**Addendum to "Application for Variance or Appeal," based on 2002 Building Code of NYS assembly exit requirements affecting crit room size (Exhibit 1) and mezzanine definition (Exhibit 4).**

Jonathan Ochshorn  
 May 31, 2013

## Addendum 2 to “Application for Variance or Appeal,” pertaining to Exhibit 1 and Exhibit 4 (Rev.1)

**Addendum 3 to "Application for Variance or Appeal": Review of documents in the City of Ithaca Building Department files**

**FLOOR B1 ENLARGED PLANS**

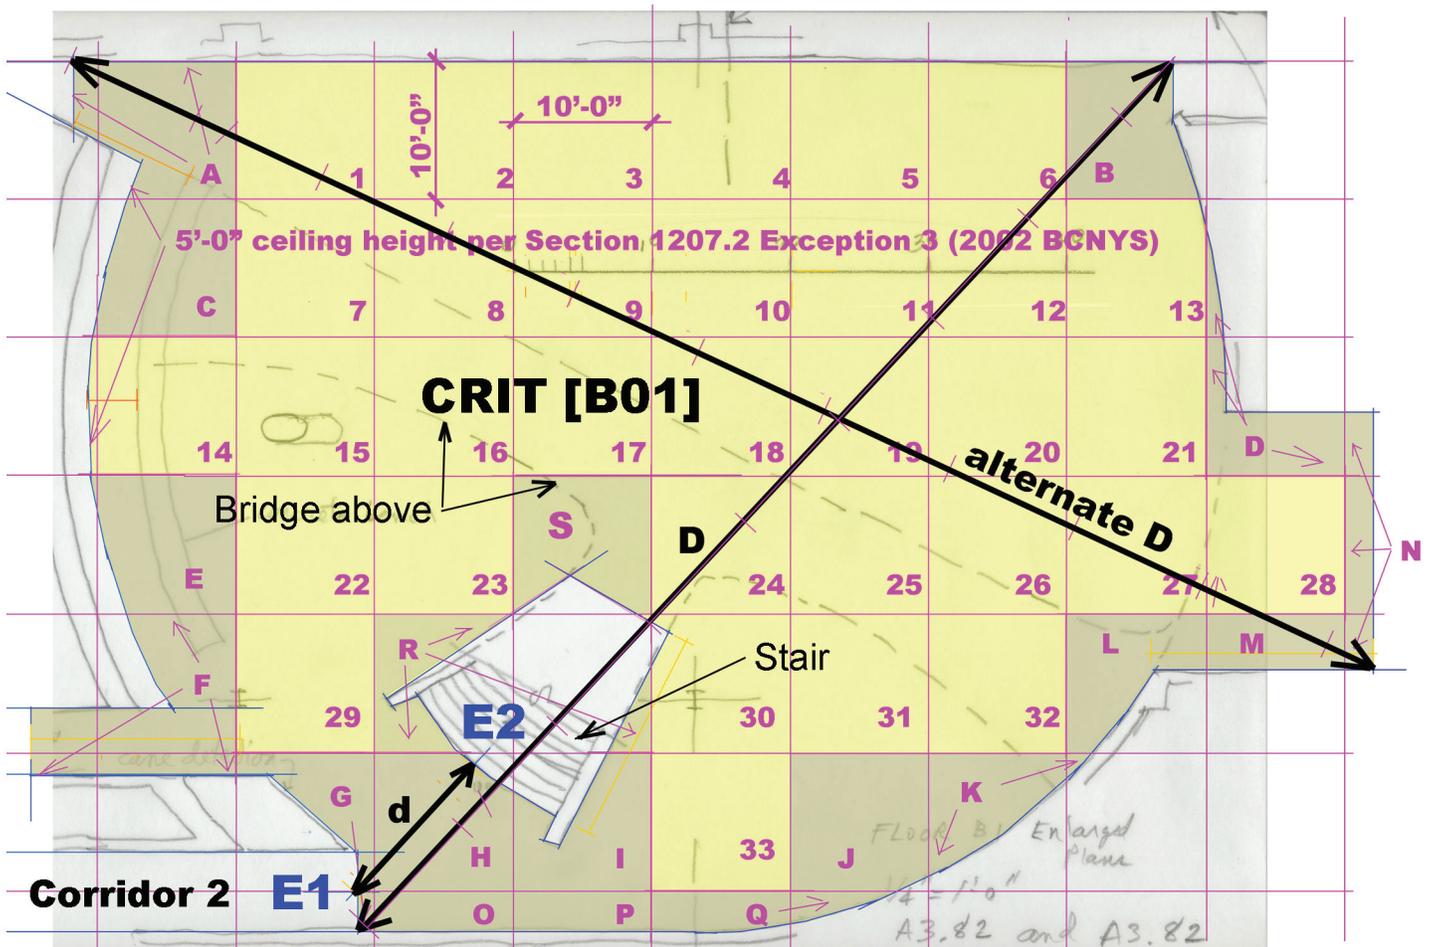
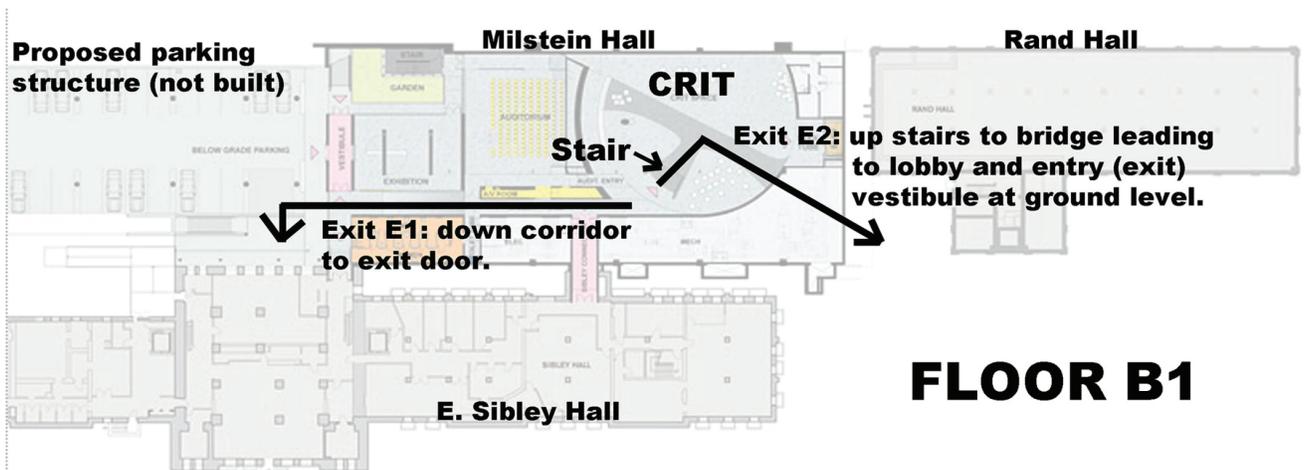
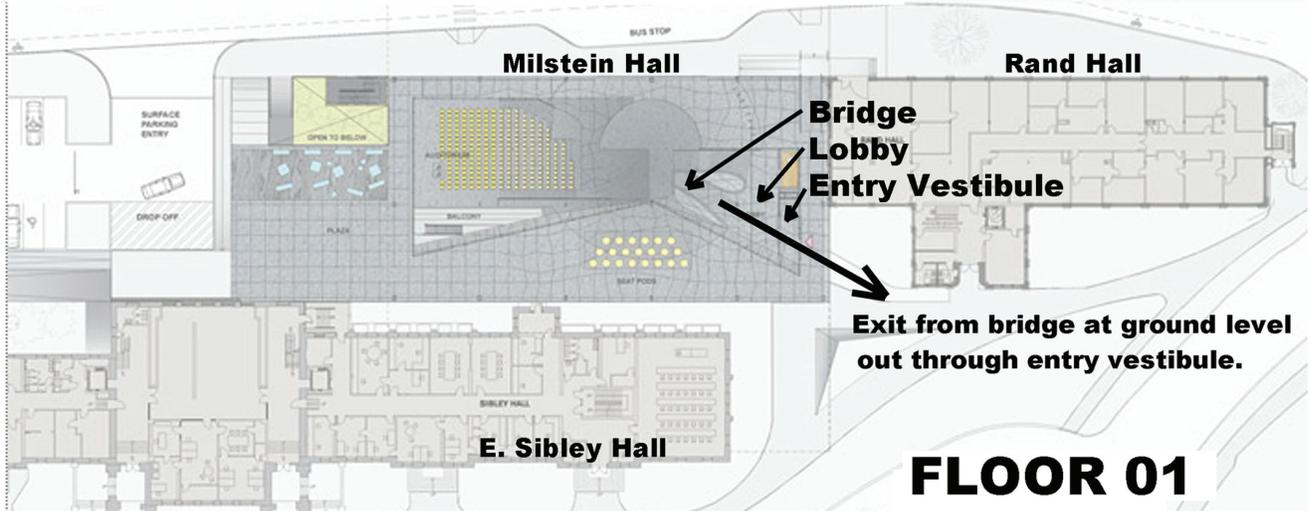
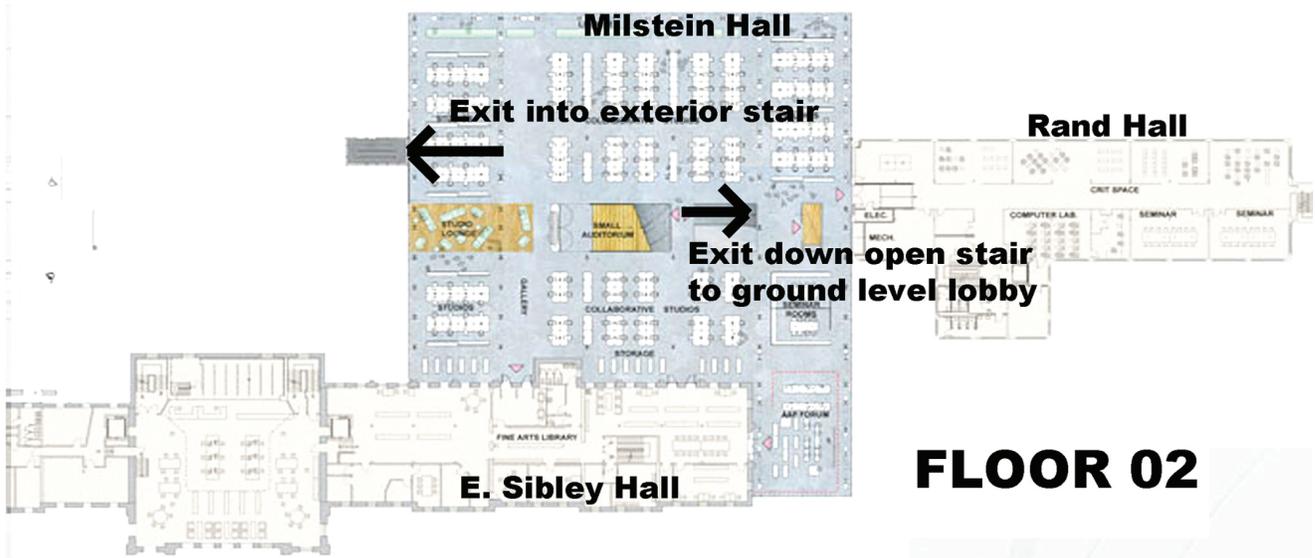
“On figure 2, you show dimensions D and d. I don’t see where these dimensions are defined in your exhibits. For areas like this, you should submit scalable drawings with dimensions so that the Board can easily look at the numbers or provide enough number so that the board can understand the problems. I am assuming that E1 and E2 are exits. Where do these exits go?”

“For the mezzanine issue, please provide sq. ft. numbers so the allowable area of the mezzanine can be calculated.”

I do not have scalable drawings, as they are the property of Cornell University and have not been made available to me, except for a half-size “Construction” set, dated Dec. 5, 2008, in the Fine Arts Library that I can examine but not photocopy. However, I have provided a carefully traced plan of the Crit room on page 2 of this addendum on which I have drawn a scaled 10-foot grid. These drawings show that the distance, *d*, between exits E1 and E2 (shown in Figure 2 of Exhibit 1) is **12’-0”** and that the “diagonal” distance, *D*, shown in the same figure, is **85’-0”**. I have confirmed the 12’-0” exit separation distance with a tape measure in the actual space.

The exit paths are shown superimposed on plans available on Cornell’s Milstein Hall website, reproduced on page 3 of this addendum. Exit E1 goes down a corridor labeled “Corridor 2” on the working drawings and exits through a door to a below-grade exterior passageway leading to a parking lot. Exit E2 goes up a stair within the Crit room to a “bridge” that leads to the ground level lobby and entry vestibule. These are the only exits from the Crit room space.

From the carefully scaled Crit room plan shown on page 2 of this addendum, the **Crit room floor area is 4580 square feet**. This is based on the total area, excluding the stair, up to a point where the domed ceiling height is 5 feet above the finish floor, per Section 1207.2 of the 2002 Building Code of NYS, Exception 3. This differs from the 4978 square foot figure provided by the Architects, but does not change any of the conclusions about the allowable Crit room size based on the number of exits (see the first Addendum).

**TOTAL AREA = 3300 + 1280 = 4580 s.f.**

**Figure 1. Common path of egress travel shown superimposed over "moveable wall plans" provided by the building architects on Dec. 10, 2010 exceeds 75 feet (email from Kim Cleveland of Accufab to Ziad Shehab of OMA Architects; blue lines and dimensions added by J. Ochshorn)**

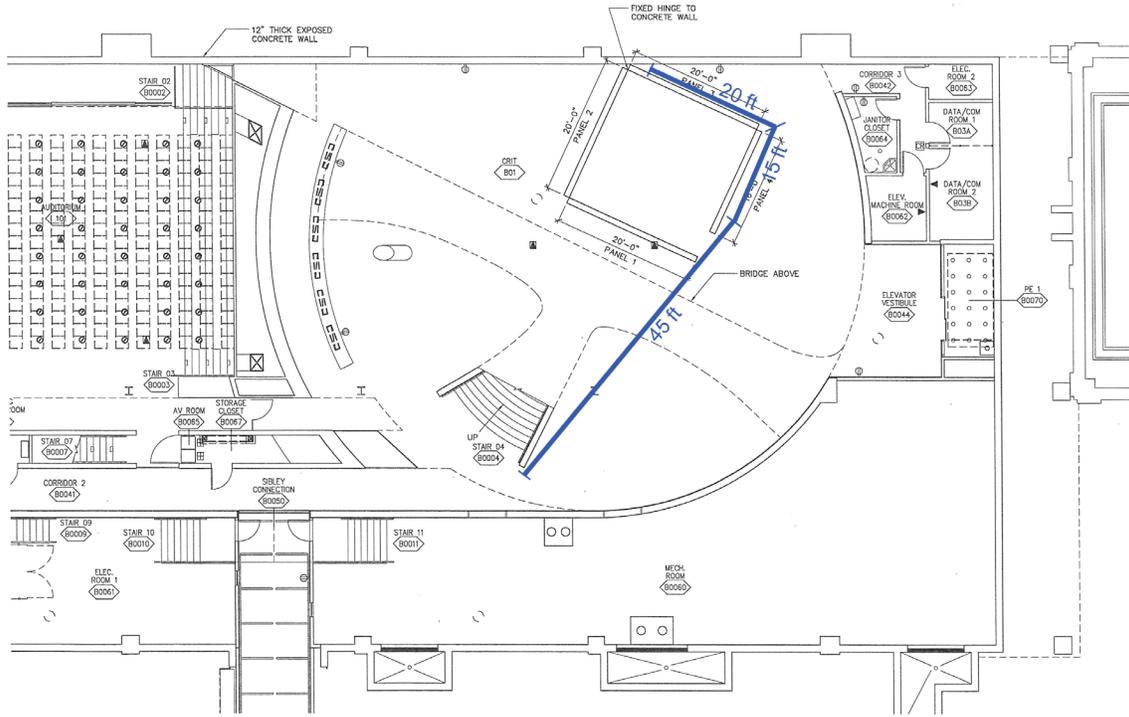
A plan of the crit room, found in the Building Department files for Milstein Hall, shows a 71-foot "Common Path" drawn as a straight line from the northeast "corner" of the room to the edge of the stair. As described in Exhibit 1, the common path of egress travel should be "assumed to be the natural path of travel without obstruction," and not an abstract "as-the-crow-flies" straight line. This is especially true now that permanent partitions have been installed in the room; such partitions can be configured so that the common path of egress travel cannot possibly be within the 75-foot limit (see Figure 1 based on "Moveable Wall Plans" prepared by OMA Architects).

But even without those partitions, the common path of egress travel requirement is not met in the crit room space, except by abstracting from all consideration of chairs, tables, or other impediments.

Figure 3. Fire separation shown separating the basement of Sibley from Milstein Hall (red lines have been added by J. Ochshorn to match what appeared in the original colored drawings, prepared by KHA Architects, dated 5/5/09).

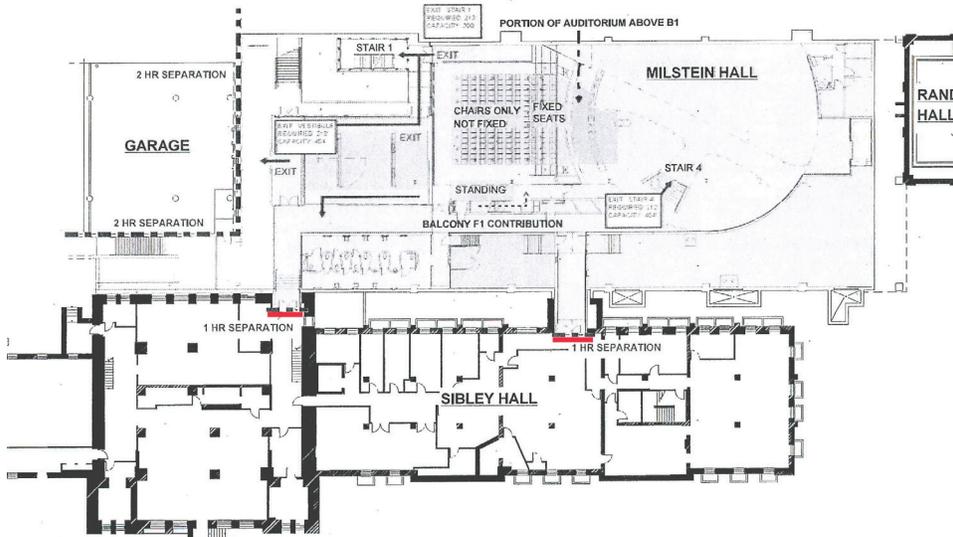
Fire barriers between Milstein Hall and the existing buildings (Sibley and Rand Halls) do not appear to be shown at all in the "Issued for Construction" Dec. 5, 2008 drawings. However, they *are* shown in a series of plans dated May 5, 2009, prepared by KHA Architects.

In these May 5, 2009 plans, one-hour fire separation is shown between the basement of Sibley and Milstein Halls (Figure 3), but only at the points of connection, and not for the windows in the basement of Sibley (although fire protection at those windows appears to have been provided).

Figure 4. Fire separation at the ground level of Milstein Hall (red lines have been added by J. Ochshorn to match what appeared in the original colored drawings, prepared by KHA Architects, dated 5/5/09).

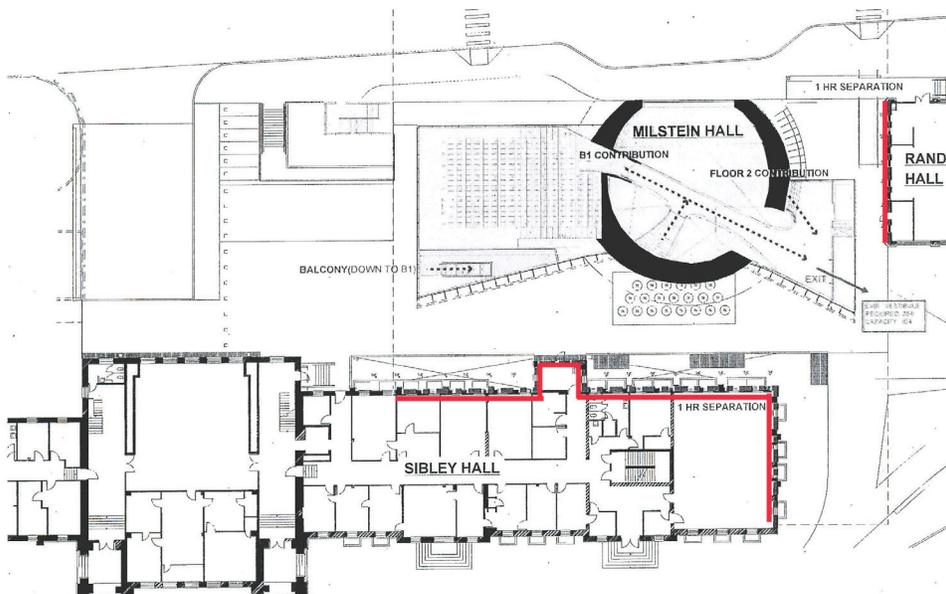
One-hour fire separation is shown between the first floors of Sibley and Milstein Hall and between Rand Hall and Milstein Hall (Figure 4). Fire protection at Rand Hall does not appear to have been provided, as a window and exhaust duct remain in that wall without any fire-resistance rating.

Figure 5. Fire separation shown at the upper level of Milstein Hall (red lines have been added by J. Ochshorn to match what appeared in the original colored drawings, prepared by KHA Architects, dated 5/5/09).

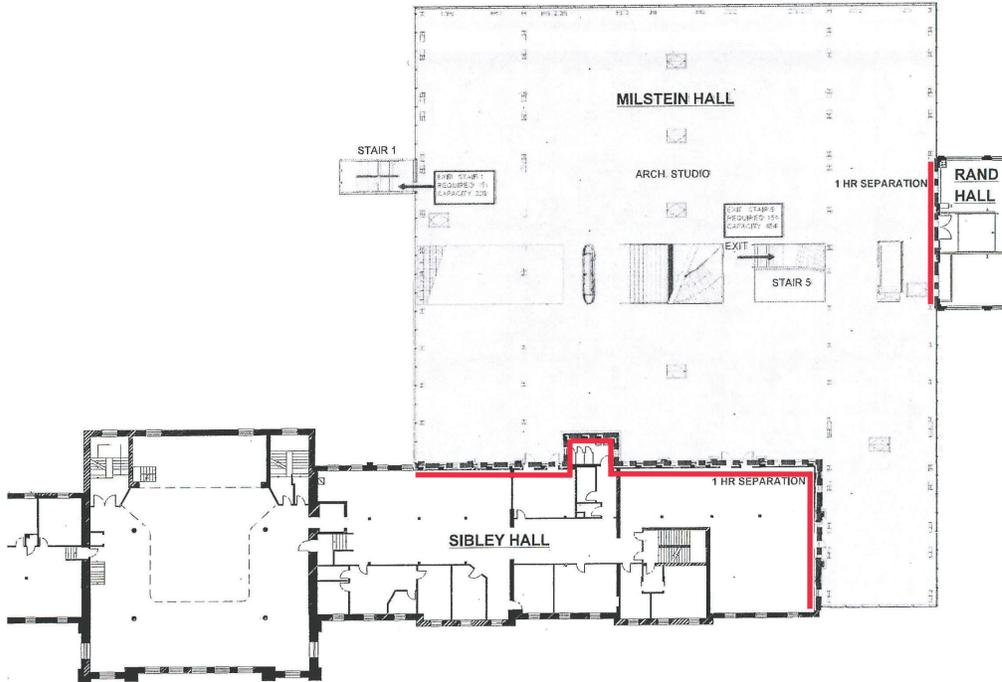
One-hour fire separation is shown at the second floor of Sibley and Rand Halls (Figure 5). Exhibit 3 describes how these fire barriers, as designed and built, do not appear to satisfy Code requirements that limit the aggregate opening width.

Figure 6 Plans show mezzanine as though it is within the combined crit room, auditorium, and the corridor connecting them.

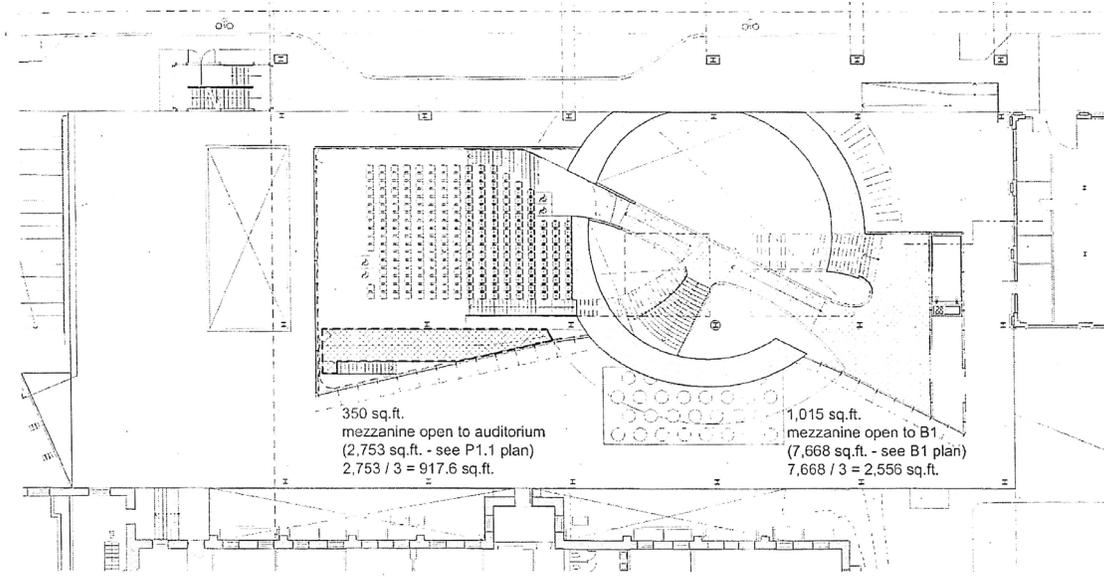
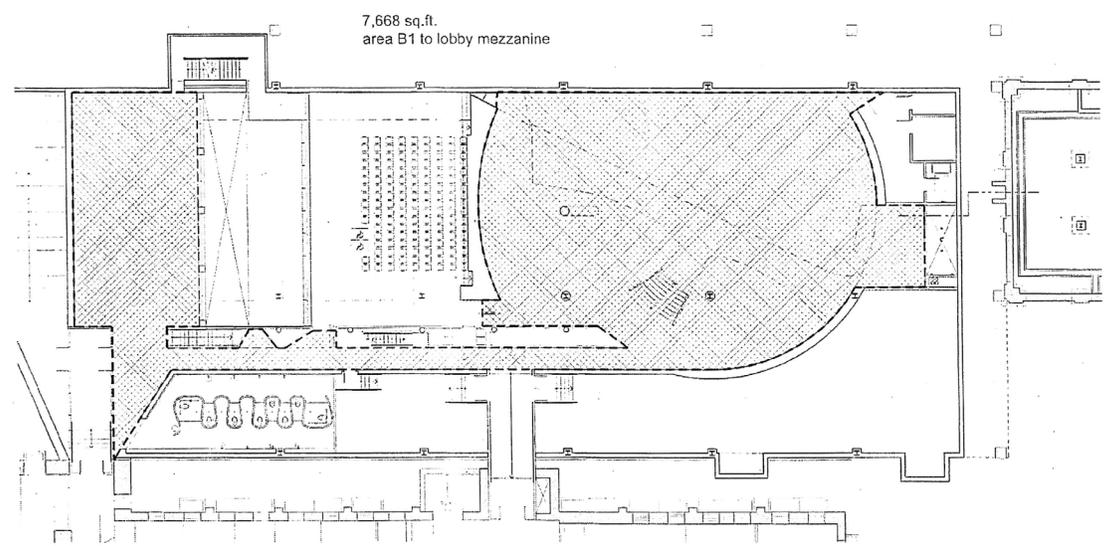
An email conversation between Larry Burns (KHA Architects) and Ziad Shehab (OMA Architects) shows that preliminary assumptions governing the designation of the lobby and bridge in Milstein Hall as a mezzanine were flawed. In order to increase the area of the room in which the mezzanine was located, that "room" was defined as a combination of the crit room, the lower part of the auditorium, *and* the corridor that connects the two spaces (see Figure 6 below). The building plans were altered subsequent to this email, so it is difficult to know exactly what the current assumptions are. The email thread reads as follows:

**Ziad, we have a problem. With the increased Mezzanine area we now exceed the definition of mezzanine below** and will be considered an atrium again..."  
(emphasis added).
